<b>HYUNDAI</b> <b>Technical Service Bulletin</b>	GROUP <b>RECALL</b>	NUMBER <b>21-01-022H-1</b>
	DATE <b>DECEMBER 2021</b>	MODEL(S) <b>APPLICABLE VEHICLES BELOW</b>
<b>SUBJECT:</b> ENGINE INSPECTION / REPLACEMENT (RECALL CAMPAIGN 198)

This TSB supersedes TSB# 21-01-022H to revise the Warranty Information and Service Procedure.

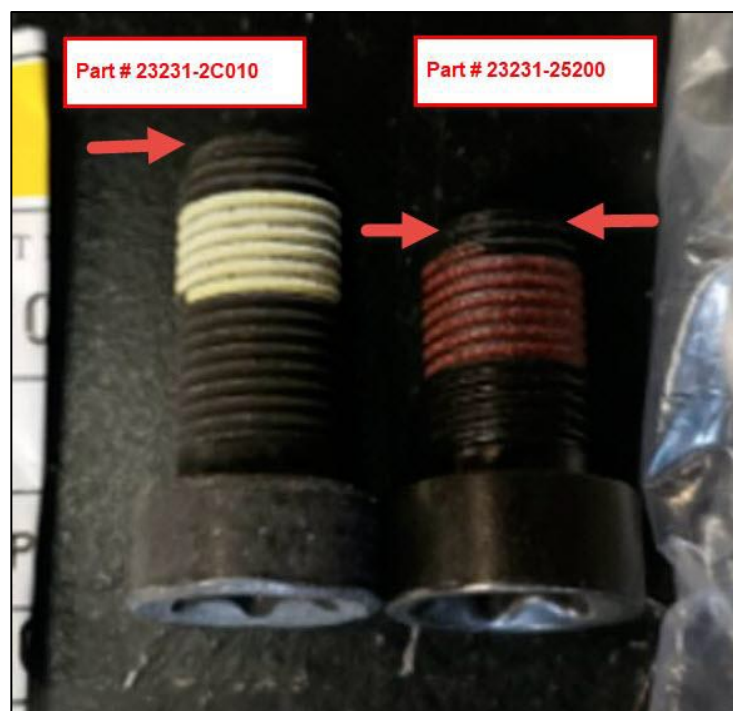
For 11-12MY Sonata Hybrid (YF HEV):

When installing a new engine, the drive plate bolts must be replaced with P/N 23231-25200.

- ❖ Due to changes to the crankshaft design, the existing bolts are ~2mm too long and will result in improperly fastened drive plate if reused.
- ❖ The 13-15MY version drive plate bolts (P/N 23231-25200) are correct length for the new engine and will provide proper fastening during engine installation.
